# Access Compliance Report

### (Curb Ramps)

Intersection ID: 15599	Main Street: COLVILLE_RD	Cross Street: EASTOVER_RD	Location: NW
ADA ID: E16973EDA403	Ramp Type: PerpDiag	Initial Pass/Fail: Fail	Overall Compliance: No
Codes/Mitigation Info/Possible Solution		Field Measurements/Component Compliance

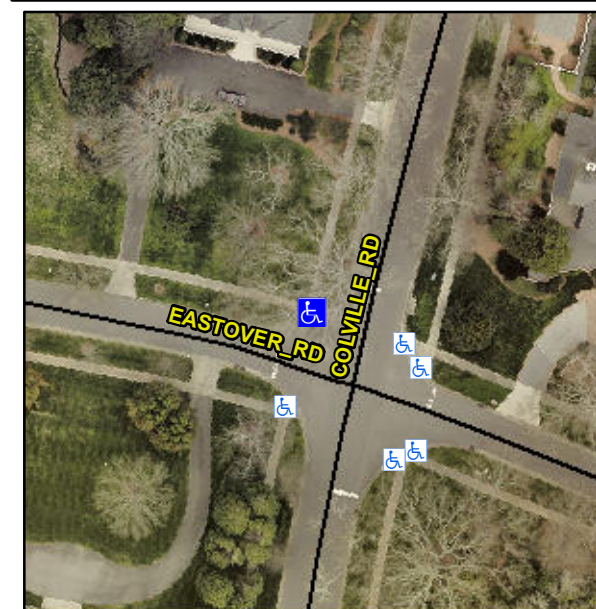
**Not Found, R304.5.3**

Compliance	Description	Data	Compliance	Description	Data
N/A	Ramp Length (in)	58.0	Yes	Ramp Slope (%)	6.5
Yes	Ramp Width (in)	48.0	No	Ramp XSlope (%)	3.5
N/A	Flare Type LT	N/A	N/A	Flare Type RT	N/A
N/A	Flare Slope LT (%)	N/A	N/A	Flare Slope RT (%)	N/A
N/A	Flare Traversable LT?	N/A	N/A	Flare Traversable RT?	N/A
N/A	Landing Length (in)	N/A	N/A	DWS Provided?	N/A
N/A	Landing Width (in)	N/A	N/A	DWS Contrast?	N/A
N/A	Landing Slope (%)	N/A	N/A	DWS Length (in)	N/A
N/A	Landing X Slope (%)	N/A	N/A	DWS Full Width?	N/A
N/A	Landing Curb? (Y/N)	N/A	N/A	DWS Offset (in)	N/A
N/A	Shared Landing?	N/A			
N/A	Gutter Ponding?	N/A	N/A	Gutter Slope (%)	N/A
N/A	Gutter Lip Ht (in)	N/A	N/A	Gutter X Slope (%)	N/A
N/A	Painted X Walk1?	No	N/A	Painted X Walk2?	No
	X Walk 1 Direction	To SW		X Walk 2 Direction	To SE
N/A	X Walk 1 Width (in)	N/A	N/A	X Walk 2 Width (in)	N/A
	X Walk 1 Slope (%)	0.6		X Walk 2 Slope (%)	1.5
	X Walk 1 X Slope (%)	3.0		X Walk 2 X Slope (%)	0.4

**Remove & Replace Curb Ramp With Two New Directional Ramps or Equivalent.**
